Access Compliance Report

Public Rights-of-Way

Intersection ID: N/A	Main Street: LANGWELL_LN	Cross Street: HAMILTON_BRIDGE_RD	Location: NE
ADA ID: 60F7B096D9EE	Ramp Type: Perp	Initial Pass/Fail: Fail	Overall Compliance: No
Codes/Mitigation Info/Possible Solution		Field Measurements/Component Compliance	
Severity Score: 33.75

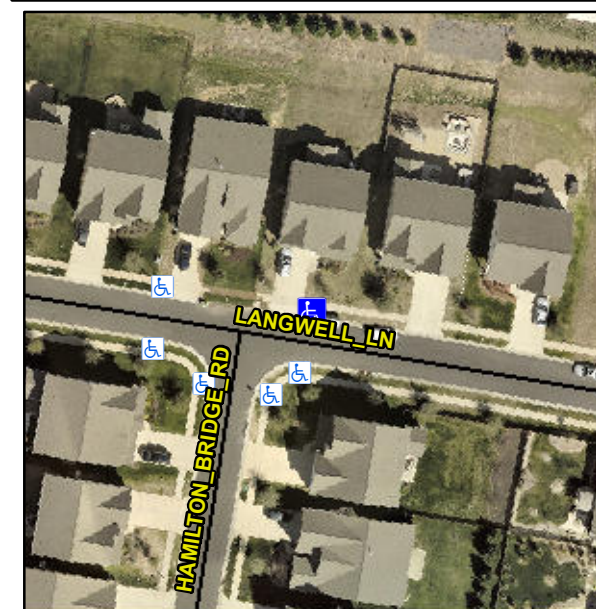
Not Found, R304.5.1, R304.2.2

Compliance	Description	Data	Compliance	Description	Data
N/A	Ramp Length (in)	47.0	No	Ramp Slope (%)	13.2
No	Ramp Width (in)	47.0	Yes	Ramp XSlope (%)	1.8
N/A	Flare Type LT	N/A	N/A	Flare Type RT	N/A
N/A	Flare Slope LT (%)	N/A	N/A	Flare Slope RT (%)	N/A
N/A	Flare Traversable LT?	N/A	N/A	Flare Traversable RT?	N/A
N/A	Landing Length (in)	N/A	N/A	DWS Provided?	N/A
N/A	Landing Width (in)	N/A	N/A	DWS Contrast?	N/A
N/A	Landing Slope (%)	N/A	N/A	DWS Length (in)	N/A
N/A	Landing X Slope (%)	N/A	N/A	DWS Full Width?	N/A
N/A	Landing Curb? (Y/N)	N/A	N/A	DWS Offset (in)	N/A
N/A	Shared Landing?	N/A			
N/A	Gutter Ponding?	N/A	N/A	Gutter Slope (%)	N/A
N/A	Gutter Lip Ht (in)	N/A	N/A	Gutter X Slope (%)	N/A
N/A	Painted X Walk1?	No	N/A	Painted X Walk2?	N/A
	X Walk 1 Direction	To SW		X Walk 2 Direction	N/A
N/A	X Walk 1 Width (in)	N/A	N/A	X Walk 2 Width (in)	N/A
	X Walk 1 Slope (%)	0.3		X Walk 2 Slope (%)	N/A
	X Walk 1 X Slope (%)	0.6		X Walk 2 X Slope (%)	N/A

Remove & Replace Entire Ramp.
